Subject: February BAR Actions - 230 West Main Street

BAR 17-08-01
230 West Main Street
Tax Parcel 280009100, 280001000, 280009000
Brands Hatch LLC, Owner/ Fred Wolf, Applicant
Amendments to the COA – CODE Building (formerly The Technology Center)

CENTER OF DEVELOPING ENTREPRENEURS (CODE) BAR AMENDMENT SUBMITTAL

01.29.19

Previous Full Brick System

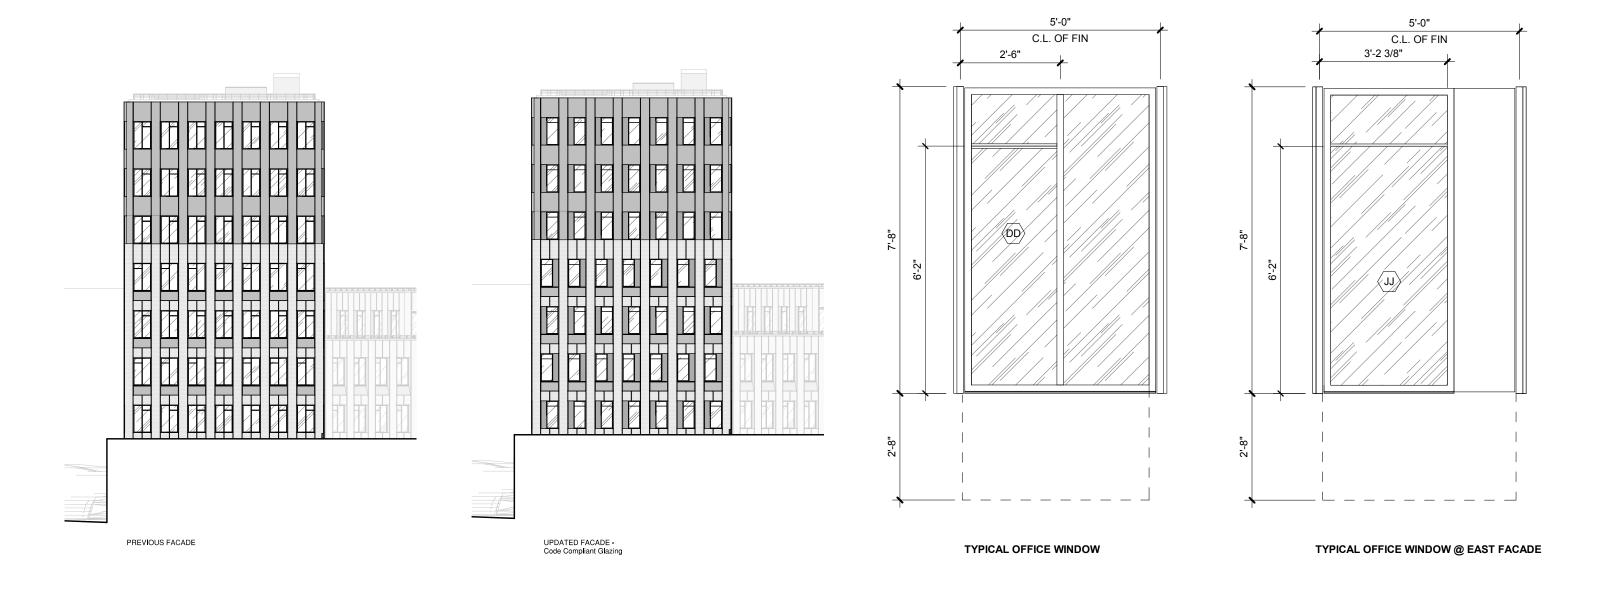
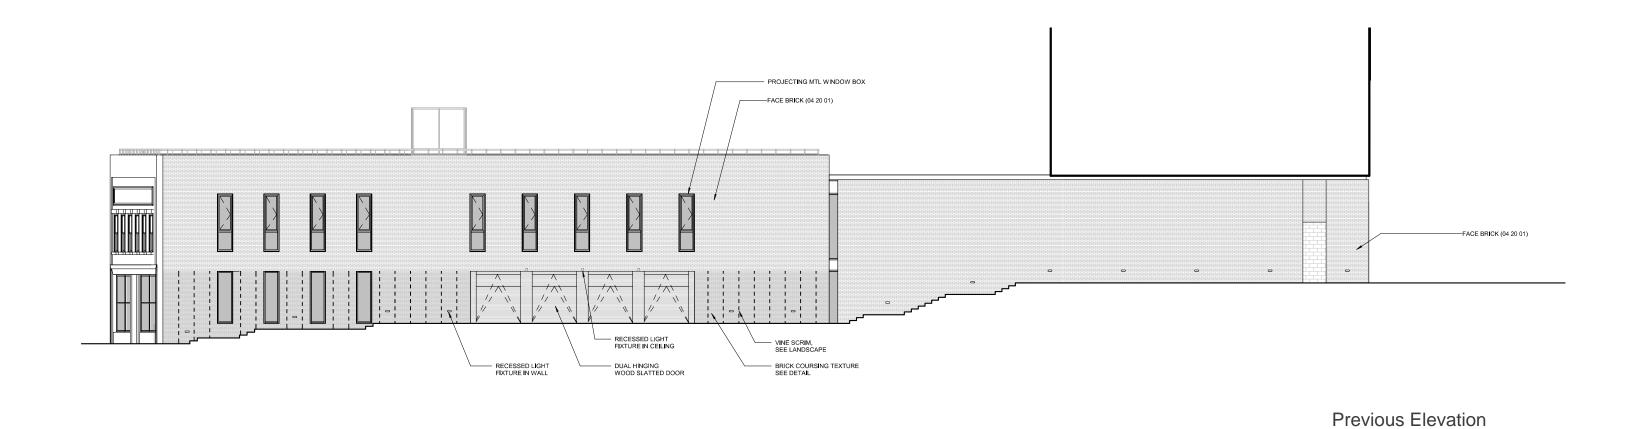
• In lieu of full sized brick, install 1" thin brick rain screen system.

- 1. In studying our wall assembly system and the structural loads and requirements of supporting a full sized brick for the envelope of this building, the design team has elected to utilize a 1" thin brick rain screen system instead. This is the same system used at the recently completed 550 Water Street and The UnCommon Building on West Main Street; both approved by the BAR. This system not only reduces weight and material / mass but it allows us to limit the need for control joints. Additionally the cavity between our brick wall and insulation panels allows us to hide fresh air intake and exhaust louvres on levels 3 through 6 so they will be invisible. This change in the contusion detail should have no affect on the appearance of our building. The bricks are largely bracketed or framed between vertical metal fins. We will continue to use the same Endicott Ironspot bricks with the same velour finish previously presented and approved. We will bring color and size samples to the meeting.

New 1" Thin Brick System

Previous Operable Window

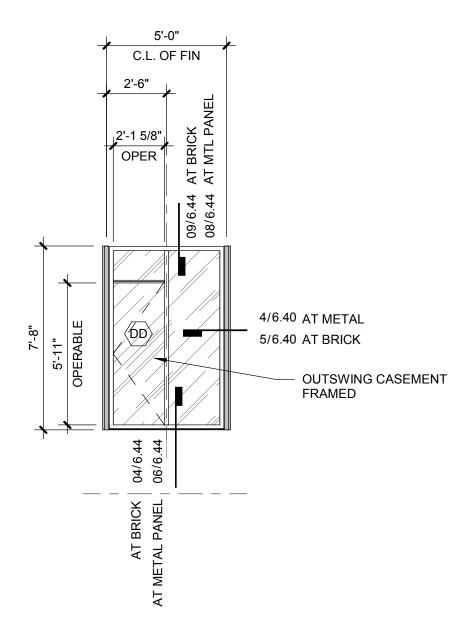
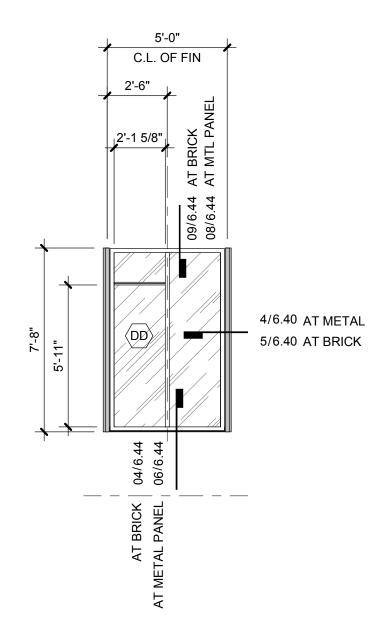
• Eliminate operable vents.

- the building's windows no longer will have an operable vent pattern of the mullions within the window units is the same
- we are adding small, discreet bollards at the top of our pedestrian gallery to prevent anyone from trying to drive vehicles over our elevated paver system at Water Street
- we are adding entry lift gates at the garage opening that will sit just inside the garage at the top of the ramp and will be fully behind the roll down security grill when its closed at night
- we are proposing a metallic 2-coat Fluropon Classic factory finish by Sherwin Williams for the fins rather than the
 previously proposed anodized medium bronze for more predicable consistency on both sheets and extruded shapes
 will bring sample

New Fixed Window

Barriers

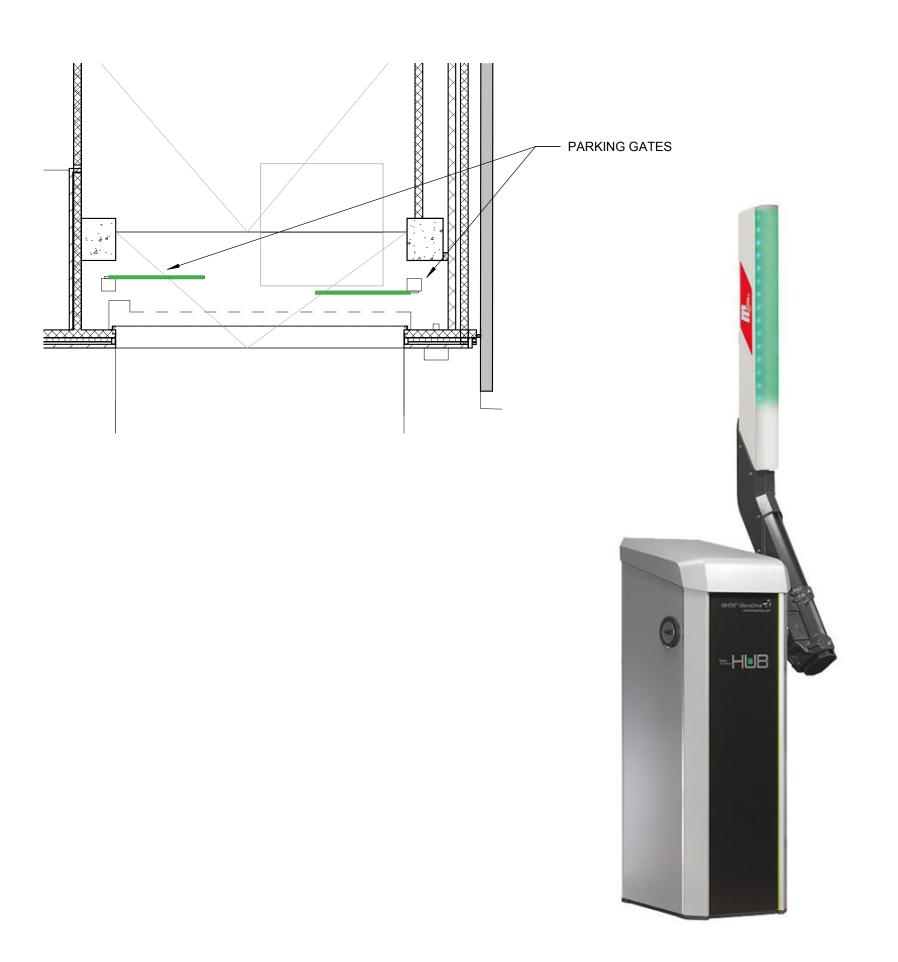
• Addition of lift gates.
